**Rezoning Transportation Analysis**  
**Petition Number: Insert Zoning Petition #2020-192**  
*General Location Identifier: Tax ID: 12306409*

**Revision Log:**

Date	Description
01-21-2021	First Review (LJ)

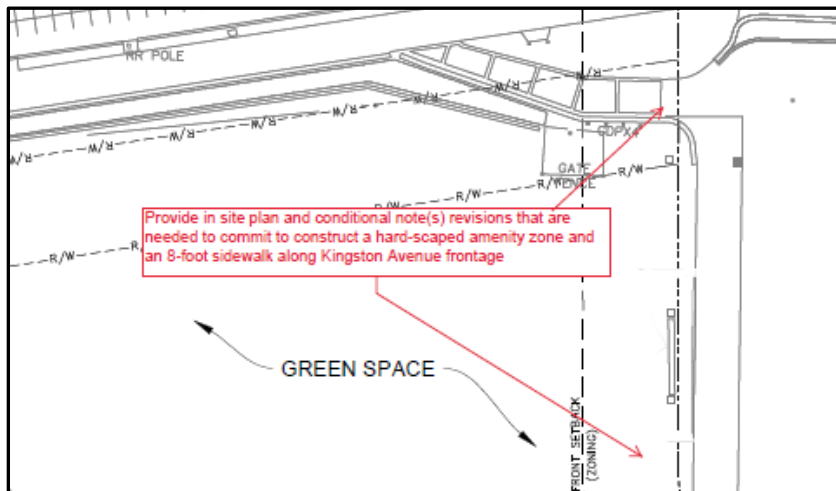
1. **Curbline:** The proposed zoning district has a setback measured from back of the existing curbline.
  - a. **Kingston Avenue:** Location of curb and gutter is in its existing location.

Label and dimension the curb and gutter from the centerline for each road on the site plan.

Reference (CLDSM standard detail U-05D.19 [TOD ONLY]) for street typical.

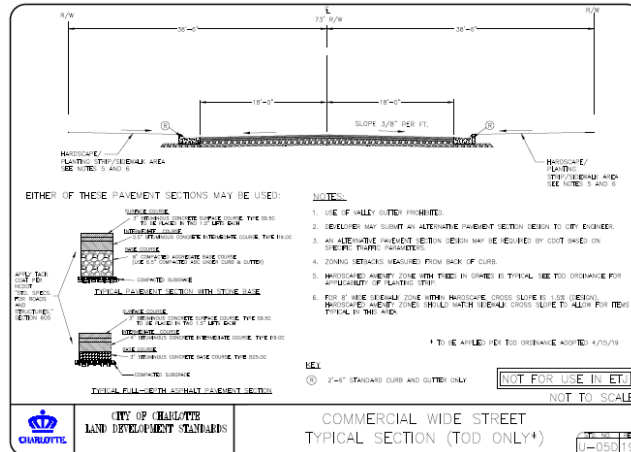
3. Revise the site plan and conditional note(s) to commit to construct a hardscaped amenity zone and an 8-foot sidewalk along Kingston Avenue frontage adjacent to proposed green space, connecting the Rail Trail access/plaza (per TOD ordinance).
